Sponsoring Party: The Empire District Electric
Company

Case No.: ER-2001-299

**Surrebuttal Testimony
of
L. W. Loos**

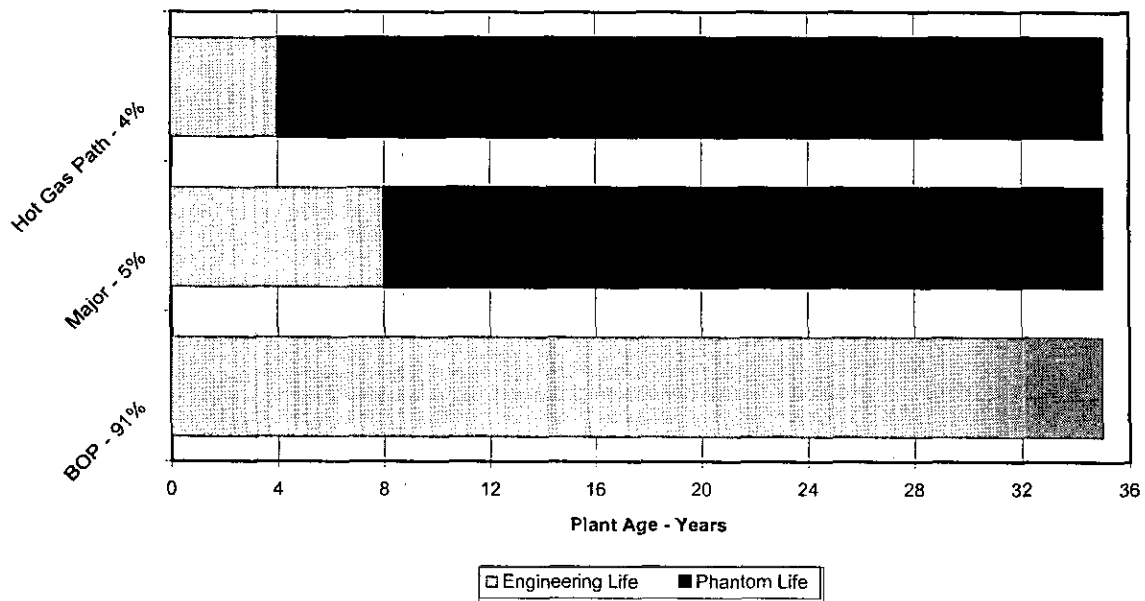
Mr. Adam, on the other hand, concluded that all plant components have an average service life of 35 years. Graphically, this difference can be shown in the following:

1 As shown in the above, the life (engineering life) for the balance of plant
2 investment amounts to 35 years. For the investment related to the Hot Gas Path
3 Maintenance Component, the engineering life amounts to 4 years. By use of a 35-
4 year average service life, Mr. Adam has added 31 years of phantom life. This
5 phantom life represents life Mr. Adam erroneously assumes will be available over
6 which to depreciate investment. This investment, however, will no longer be in
7 service after about 4 years.

8 Mr. Adam and I agree on the 35-year design life of the plant. As shown in the
9 above figure, this life applies to 91 percent of the plant investment. The remaining 9
10 percent of plant investment has a life of 4 to 8 years and should be depreciated
11 accordingly. Mr. Adam's use of a 35-year ASL, however, imputes a 35-year life to
12 all investment.
